DRB CASE ACTION LOG - BLUE SHEET

PROJECT# 1001523

NAME: LADERA BUSINESS PARK Unit 1,

DESCRIPTION OF REQUEST: SITE DEVELOPMENT PLAN FOR BUILDING PERMIT OFFICE WAREHOUSE FACILITY

SITE UTILITIES

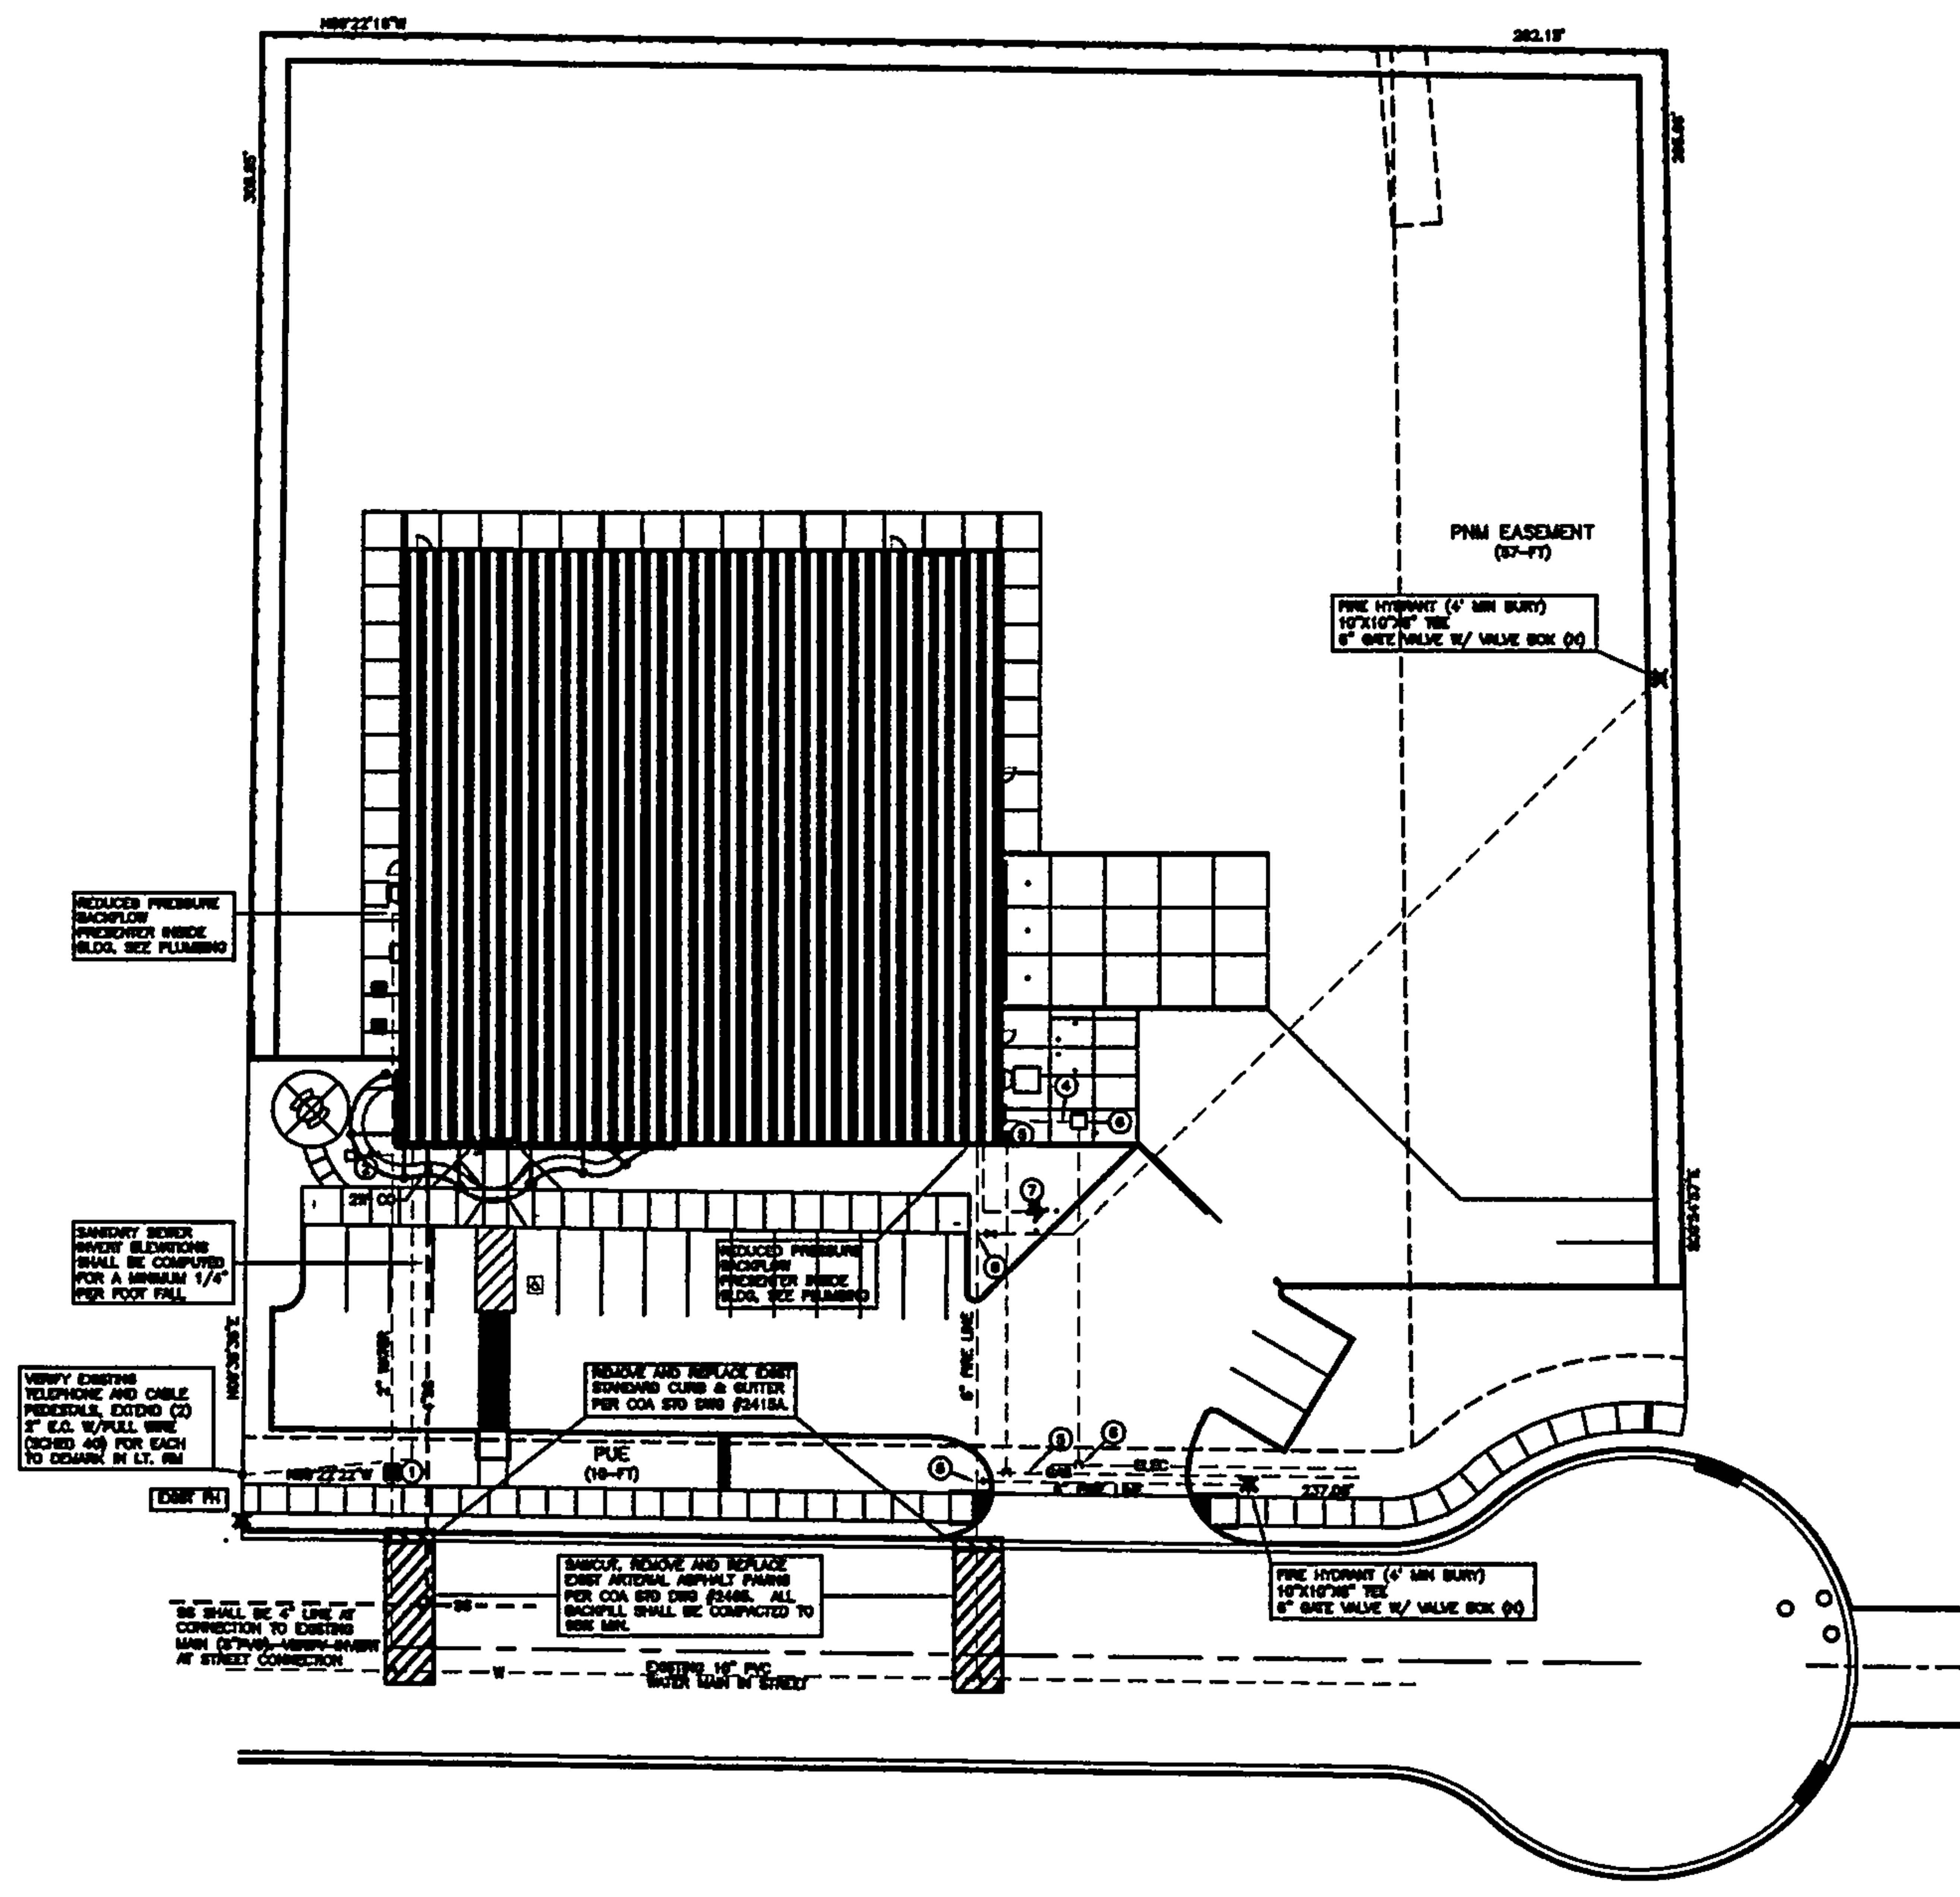
ABCWUA: Availability statement, revise FH

We have received and reviewed the following sheets for the above referenced project: Site Plan/sheet 1 of 6 (architect's stamp date 8/9/15), Landscape Plan/sheet 3 of 6 (architect's stamp date 8/10/15) Grading Plan/sheet 4 of 6 (engineer's stamp date 8/9/15), and the Utilities Plan/sheet 5 of 6 (architect's stamp date 8/9/15).

1. No permanent structures or ponding shall be installed in existing distribution easement.
2. Any trees and shrubs planted in distribution easement are subject to trimming and or removal.
3. A 10-ft wide gate will be installed, as shown at the NE corner of the site, for access by EPE and PNM at any time.

We have received, reviewed, and approved the following sheets for the above referenced project: Site Plan/sheet 1 of 6 (architect's stamp date 8/9/15), Landscape Plan/sheet 3 of 6 (architect's stamp date 8/10/15) Grading Plan/sheet 4 of 6 (engineer's stamp date 8/9/15), and the Utilities Plan/sheet 5 of 6 (architect's stamp date 8/9/15).

4. No public utilities are within the easement. A plastic (PVC) drain pipe from the truck loading dock well extends through the easement and is shown on the grading plan. Utilities shall be marked and coordinated with EPE prior to installation.
